## ADDENDUM NO. 3 TO Bid No. 24-03

Terral Linda High School Art Quad, Dust Collector, ADA Reconfigure Addendum Date: March 27, 2024

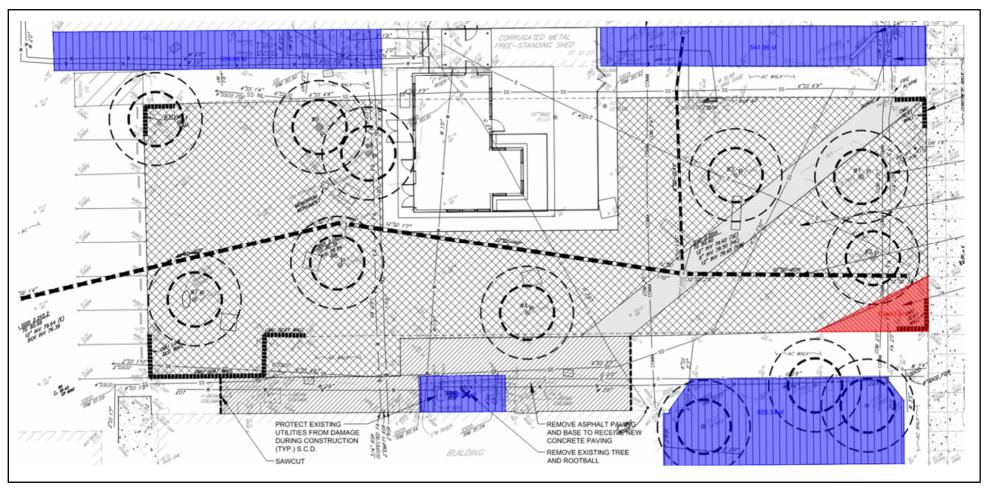
- Answer: Existing CMU walls are to be removed.
- 11. **Question**: See screenshot #3 below. Is the area highlighted in red to be removed and new topsoil imported per the note on L1.1? This area is not shown within the limits of demo or grading per C1.1, C1.2, C2.2, & C3.1. For the area in blue, please provide information on final grade needed as it is not shown on C1.2.

- Answer: Remove asphalt paving and base, install import topsoil within area for new planting, and conform to the surrounding existing paving as per L1.1. For the area in blue, clear and grub area to receive new planting. Take care in tree protection zones, see specs and detail. 12" import or in situ topsoil depth min. (typ.)
